Regarding Application #2025-00031
Westen Weaver Major Partiton

The partition hearing on July 28, 2025 for applicant Weston Weaver application # **20250033** has not answered many of the previous questions and has raised many new ones.

Subject: Evaluation of information pertaining to safety of the proposed new (3) resident access road onto Mt. Glen Rd.

RED APPLE WAY PLAN VIEW PRELIMINARY PARTITION PLAT

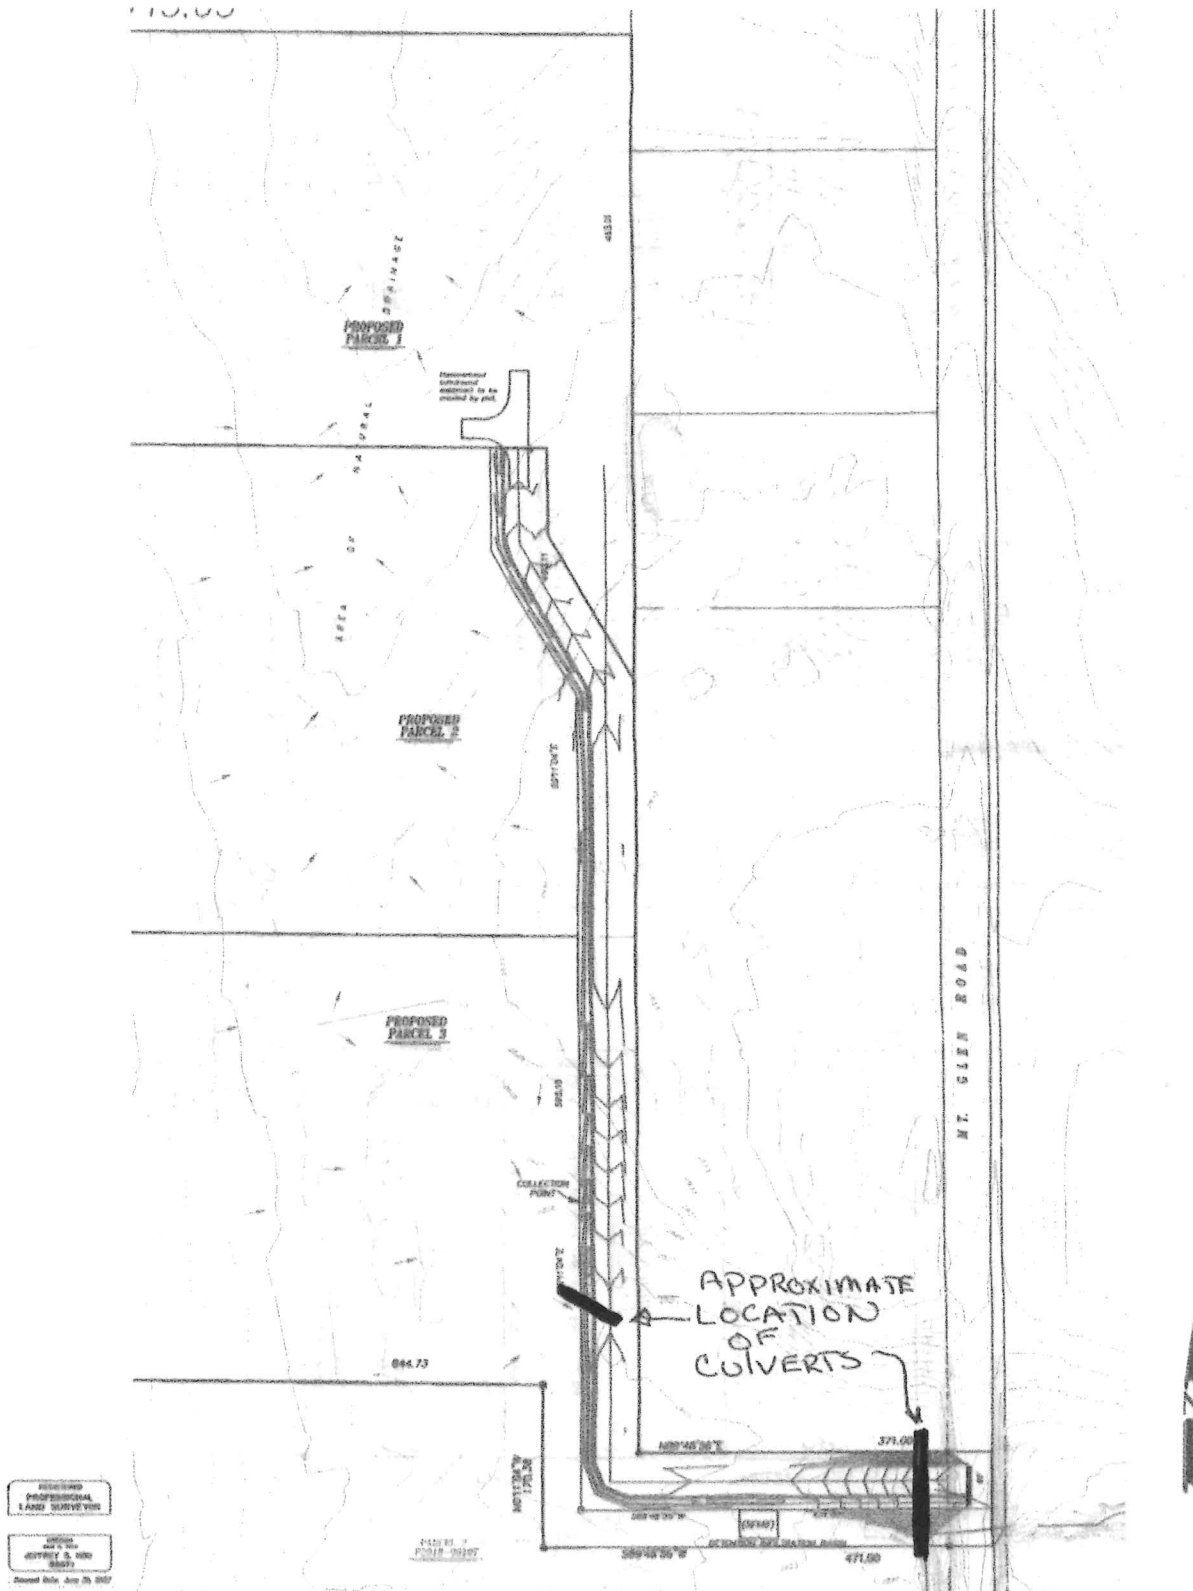
The Road design on the preliminary partition plat is not feasible as shown. The side slopes are too steep; the road surface is not level with on grade at the intersection of Mt. Glen. There is no accommodation for curve widening at the intersection with Mt. Glen.

Our property is just north and east of the proposed road. This road will both cutoff the historic runoff across our property from the west and dam the water flowing off our property to the east. We need and want this historic flow of water across our property.

See attached map for approximate location of needed culverts.
